RE: Modification Report for the Bilambil Heights Concept Plan Modification 3 (MP08_0234 MOD 3)

Enclosure: Attachment 1: Detailed DCCEEW CPHR Comments – Modification Report for the Bilambil Heights Concept Plan Modification 3 (MP08_0234 MOD 3)

Figure 4: Location of the pink underwing moth. Vegetation is lowland rainforest TEC.

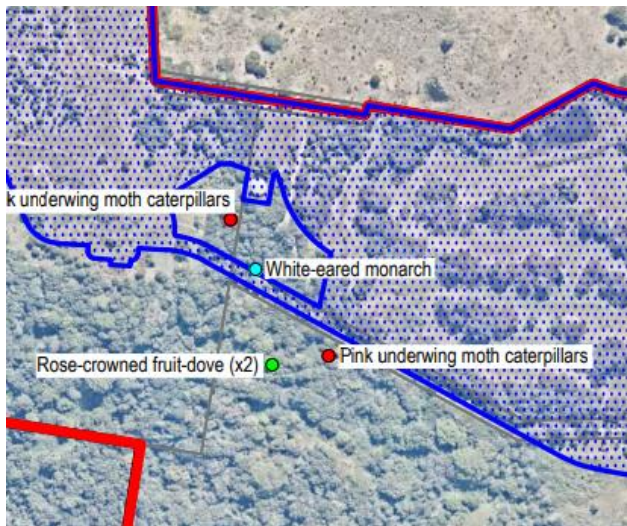
The pink underwing moth (*Phyllodes imperialis smithersi*) is listed as endangered under the BC Act. We note the pink underwing moth was not detected during biodiversity studies for the CPA. In contrast, REA 2024 confirms pink underwing moth caterpillars were recorded at 5 locations throughout the subject site. Importantly, the occurrence of caterpillars indicates the site is a

breeding site for the pink underwing moth. Two of the recorded locations are adjacent to proposed Road 22.

Based on the information provided, the proposed road will likely fragment known pink underwing moth habitat.

The development as proposed will isolate the northern breeding habitat of the pink underwing moth (see Figures 4 and 5 below) from the species' breeding habitat to the south of the proposed road. Aside from the pink underwing moth, the area to the north of the road is ecologically significant as it is lowland rainforest TEC that contains over 80 individual threatened plants.

3. The impact on the threatened pink underwing moth be further reduced by efforts to avoid impacts on the habitat of this species.

Figure 6: Aerial photograph taken around 2021. Dark purple polygon represents Restoration Area 1 (RA1) from the 2010 RSRPMP. Lilac polygons confirming the condition of an existing threatened flora offset area within RA1. The proposed Spine Road (yellow polygon) passes through the offset area.

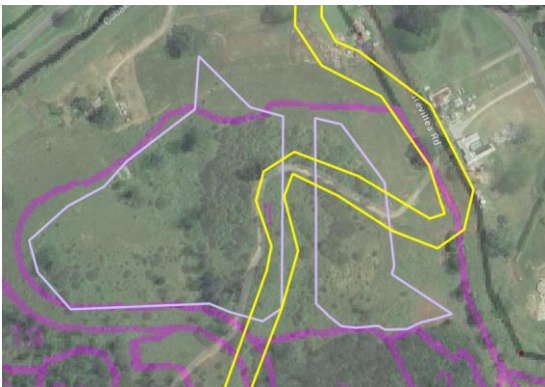
In addition, RPS indicates there is no requirement for the applicant to protect the trial planting areas, as they did not form part of the 2010 RSRPMP. This is incorrect as Section 5.1.3.5 and Figure 16 of the 2009 EA and Annexure 1 of the 2010 RSRPMP confirm the trial planting areas form part of the threatened flora offsets package proposed by the applicant (refer to Figure 6 below).

CHPR notes, Condition of Approval A2(1) requires the development of to be carried out in accordance with ecological assessments prepared by James Warren and Associates. The 3 trial planting were included in those documents.

CPHR estimate the 3 trial offset areas comprise a total of 6.57 ha. Based on a tree planting spacing of 1.8 m, the 9181 plants should have covered an area of approximately 3 ha. Our review of Nearmaps from 20 July 2010 until 22 December 2024 has confirmed the planting works were not completed.

Furthermore, Figure 8 of the 2024 REA partially maps the vegetation growing within the purple polygon in Plate 6 above, as brushbox /camphor laurel forest rather than rainforest, which is inconsistent with the planting schedules contained in Appendix 6 of the JWA EA dated 2009.

In addition, the REA 2024 does not map any threatened flora growing within offset (trial) areas depicted in Figure 6 above, even though Figure 7D of the REA 2024 confirms appropriately 80 to 90 threatened plants are located within the offset area depicted above in Figure 7.

4. The impacts on threatened flora be further reduced by avoiding the existing offset areas depicted in Section 5.1.3.5 and Figure 16 of the 2009 Environmental Assessment (EA) and Annexure 1 of the 2010 Revised Site Rehabilitation and Pest Management Plan (RSRPMP).

Figure 8: Map highlights the restoration areas to be rehabilitated by the development. Yellow and purple polygons represent RAs1-44.

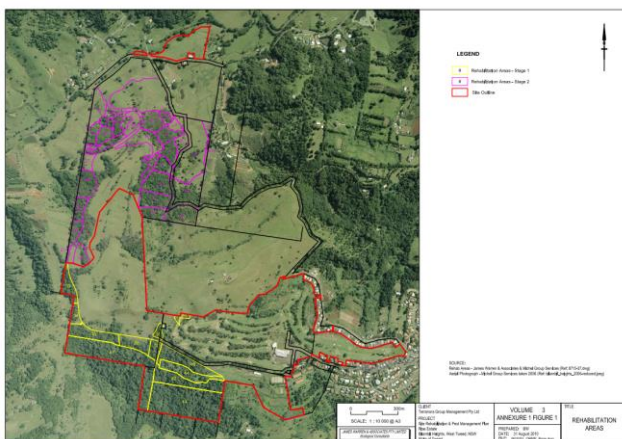
To mitigate the impact of the development on threatened flora, Section 5.1.3.4 of the 2010 REA confirmed conservation areas consisting of 44 RA's were to be established across the subject site. as shown in Figure 8 below.

Appendix 1 of the 2010 RSRPMP again confirmed the vegetation communities depicted by the purple polygons in Figure 8 below form part of the overall rehabilitation package.

The 2024 RSRPMP has removed the figure and the requirement for the applicant to rehabilitate these areas. CPHR expects that vegetation restoration commitments in the CPA would be upheld by the CPA MOD.

The 2010 REA also confirmed the subject areas would be rehabilitated over a 10-year period in accordance with the 2010 RSRPMP. In contrast, the 2024 RSRPMP has reduced the restoration period by the developer to 5 years. CPHR does not support this reduction in the operation timeframe of the RSRPMP.

8. The 2024 RSRPMP be updated to include restoration of the vegetation communities identified as Rehabilitation Areas (RA) 1-32 in the approved 2010 RSRPMP. All restoration works affected by the updated RSRPMP to be undertaken concurrently.
